Wisconsin Department of Transportation

Proposal #10: 1060-34-84
Zoo IC, Center Street Bridge
Over USH 45
USH 45
Milwaukee County

1060-35-85
Zoo IC, Center Street Sidewalk
114th Street to 117th Street
Off System
Milwaukee County

This is Addendum No. 01, which provides for the following:

Addendum No. 01
ID 1060-34-84 &
ID 1060-35-85
Revised Sheet 89
November 30, 2015

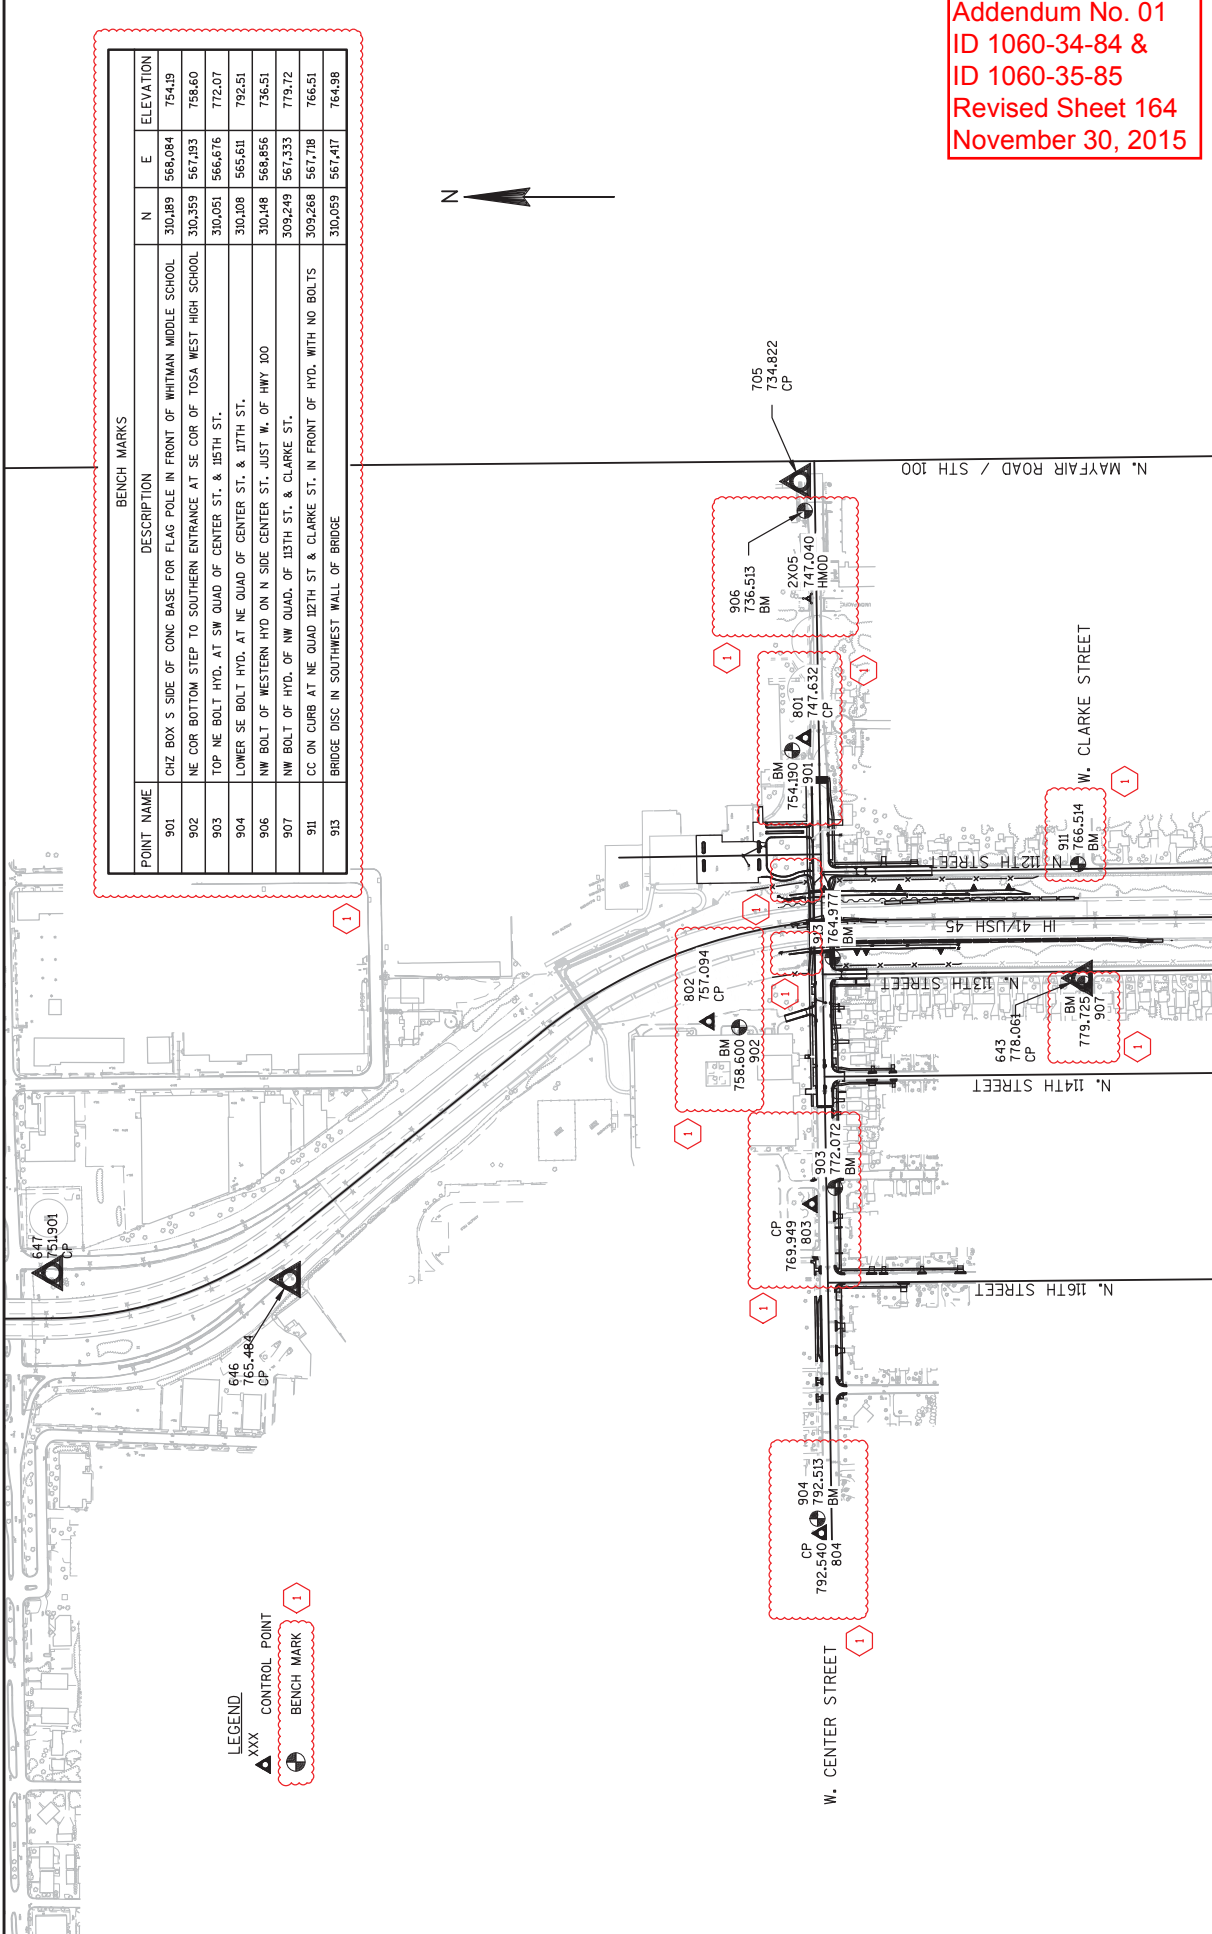
| Revised Plan Sheets | |
|---------------------|---|
| 89 | Planting – Removed sections of proposed storm sewer due to Wauwatosa storm sewer project |

Addendum No. 01
 ID 1060-34-84 &
 ID 1060-35-85
 Revised Sheet 164
 November 30, 2015

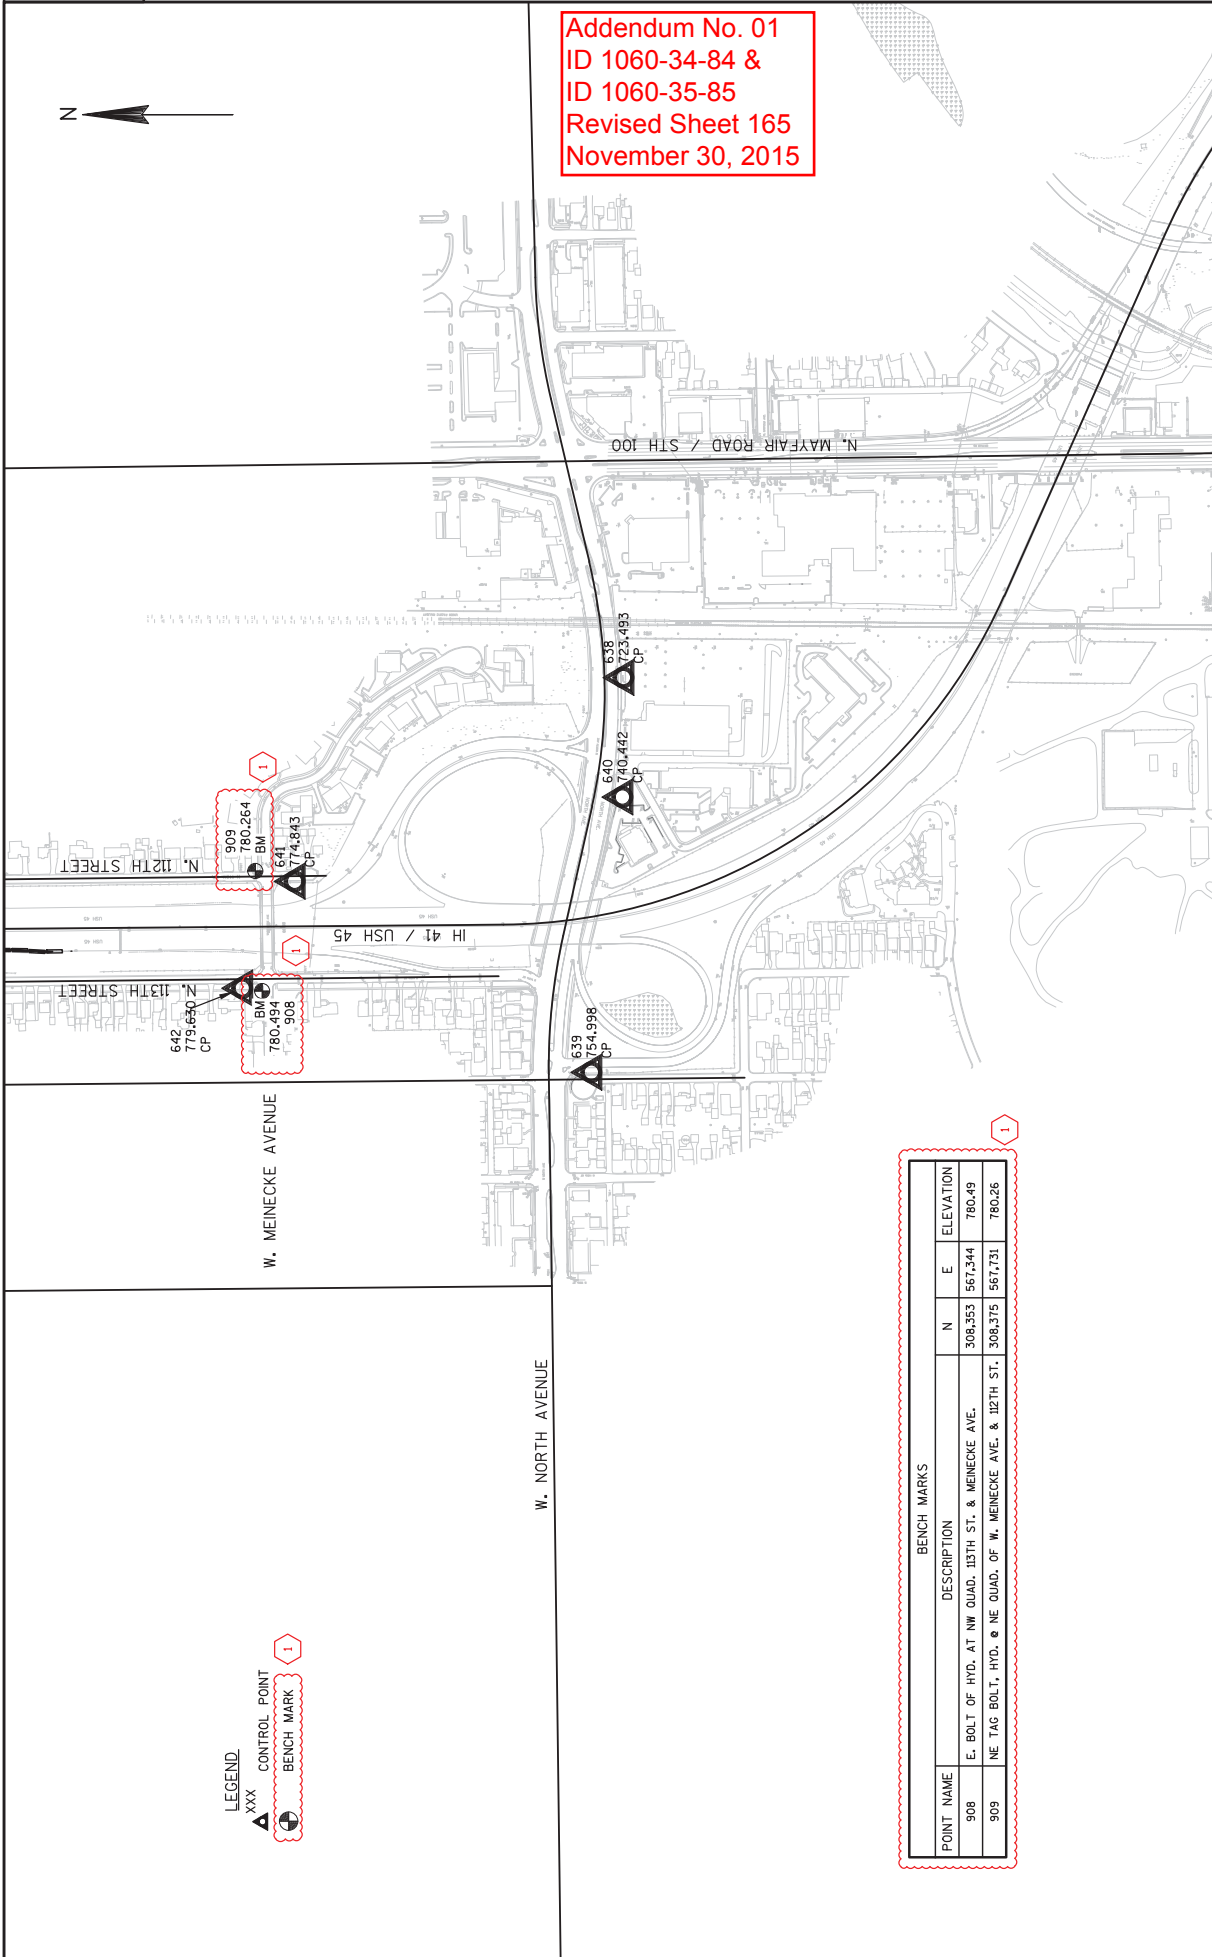
| Revised Plan Sheets | |
|---------------------|---|
| 164 | Alignment Layout - Survey Control Overview – updated survey control point data |

Addendum No. 01
ID 1060-34-84 &
ID 1060-35-85
Revised Sheet 165
November 30, 2015

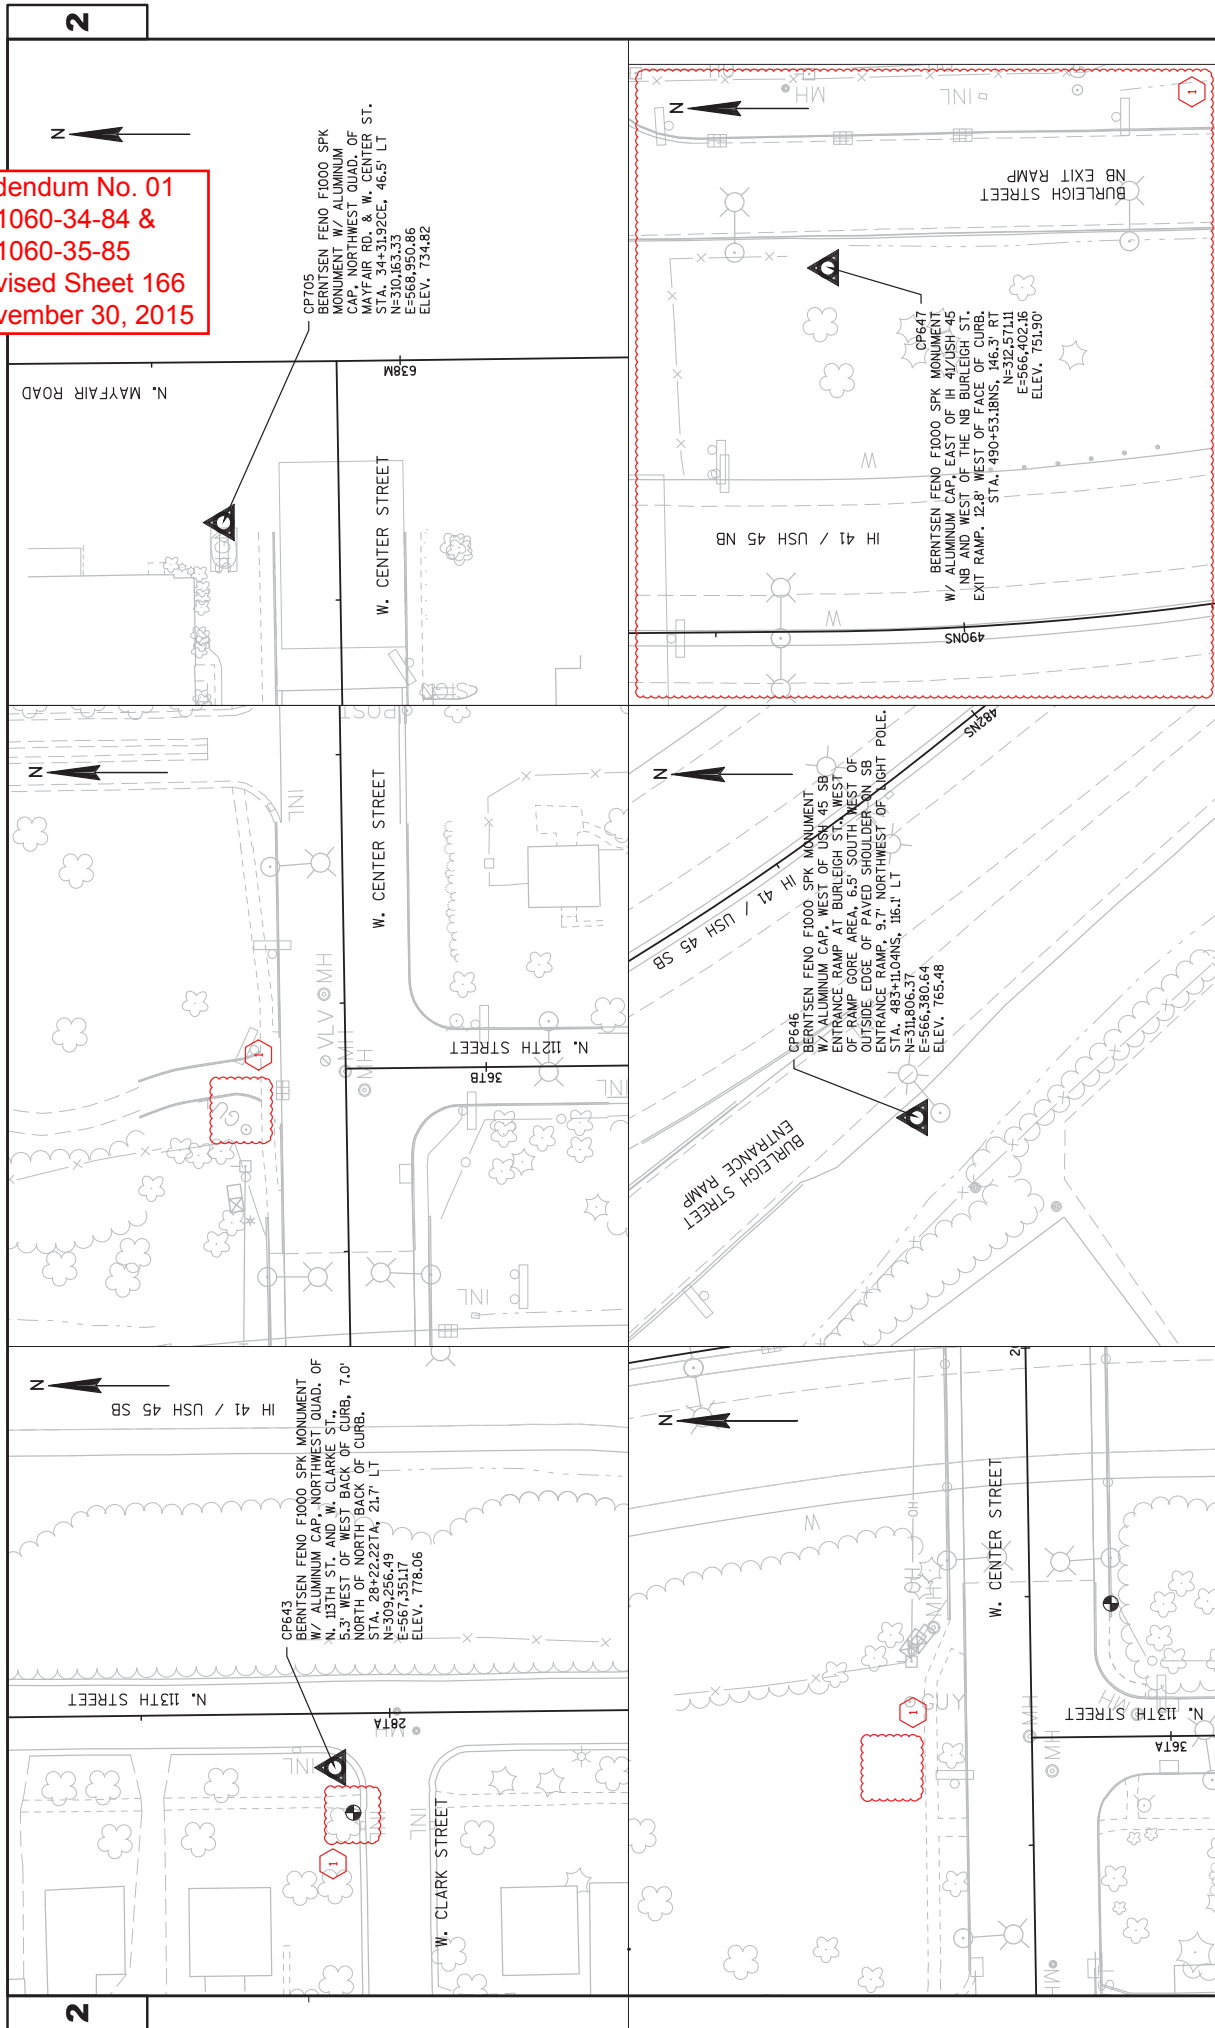
| Revised Plan Sheets | |
|---------------------|---|
| 165 | Alignment Layout - Survey Control Overview – updated survey control point data |

Addendum No. 01
 ID 1060-34-84 &
 ID 1060-35-85
 Revised Sheet 166
 November 30, 2015

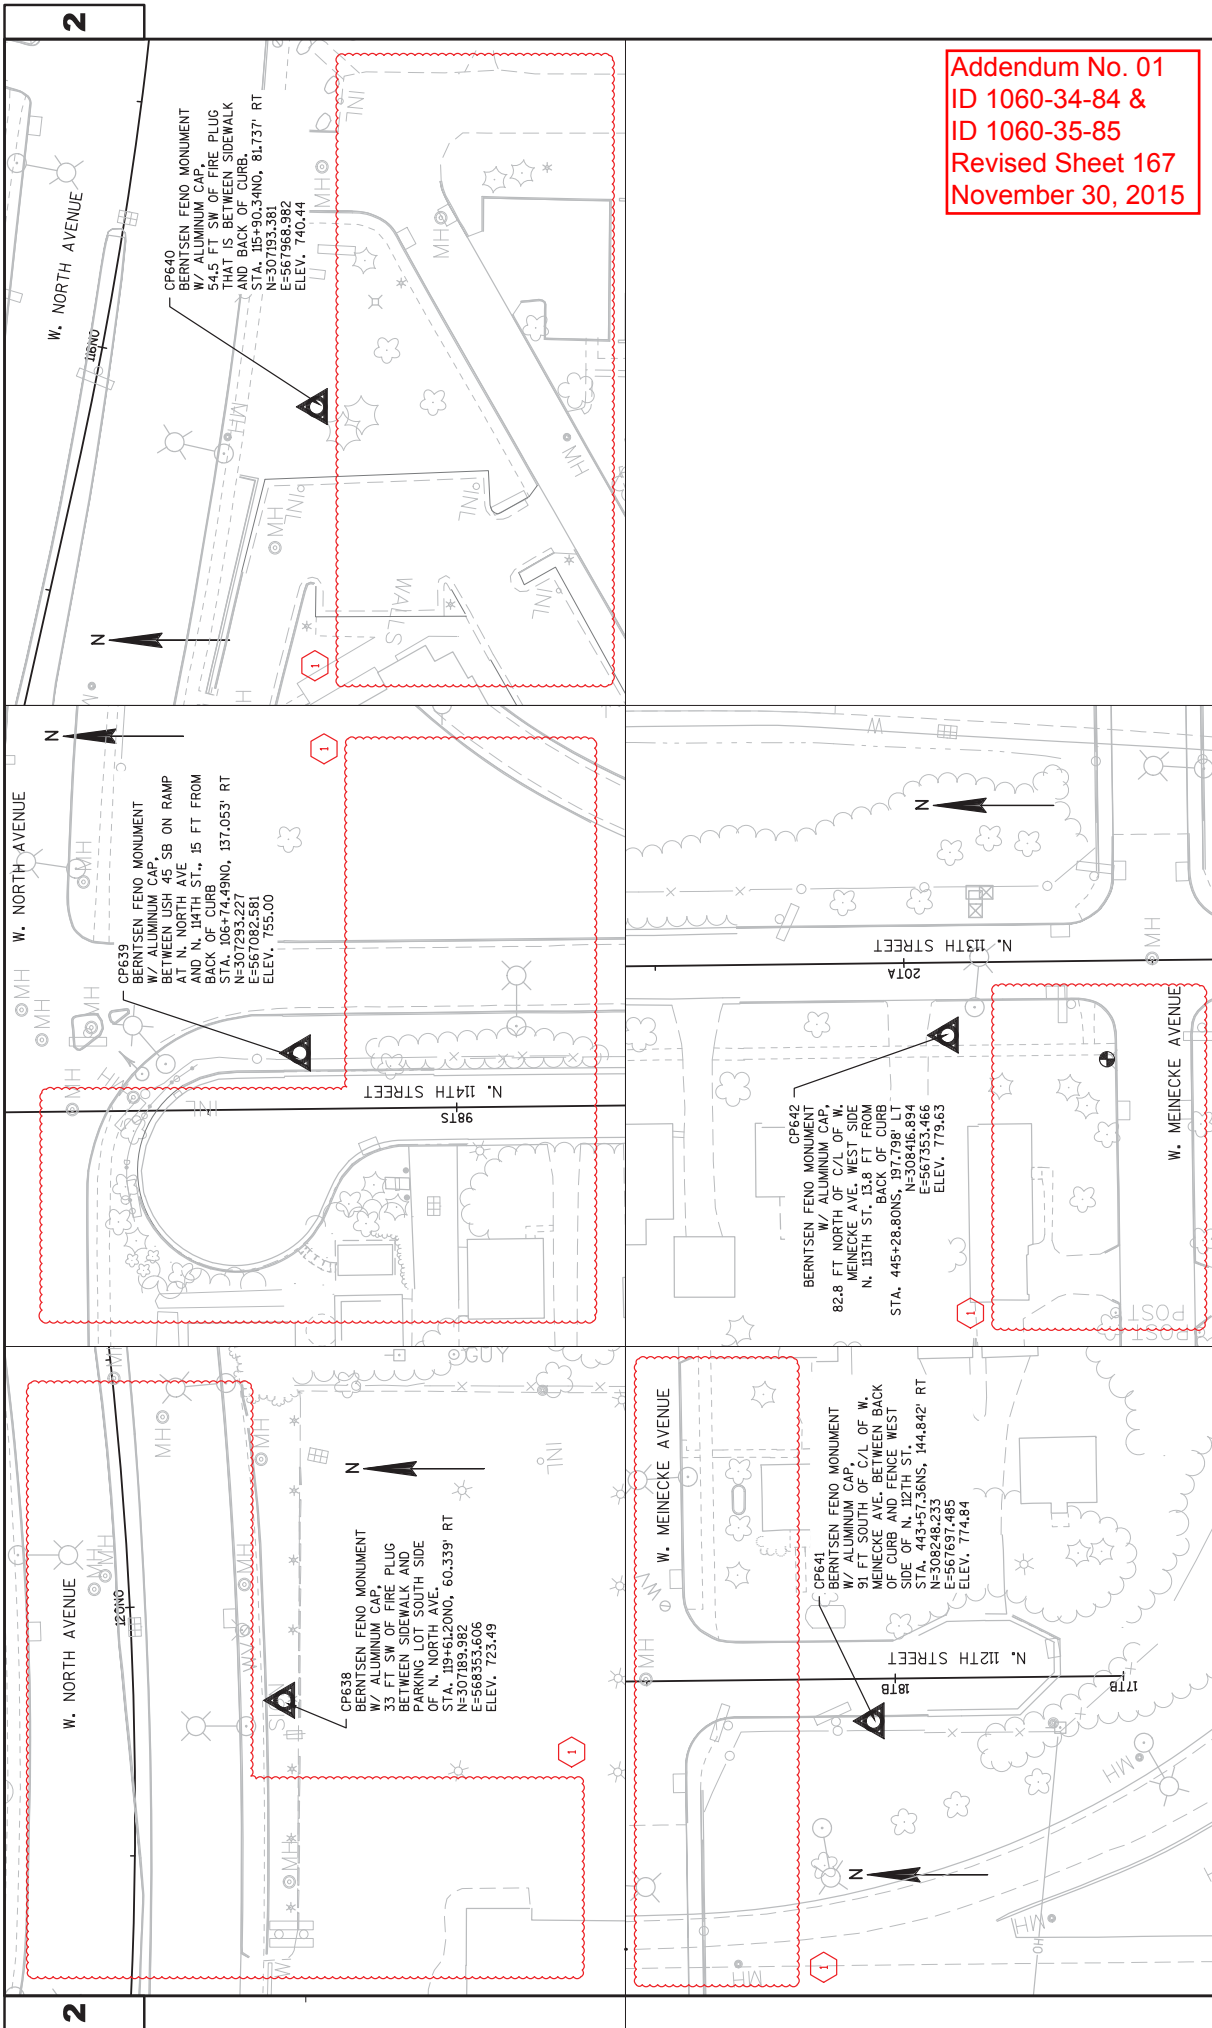
| Revised Plan Sheets | |
|---------------------|---|
| 166 | Alignment Layout - Survey Control – updated survey control point data |
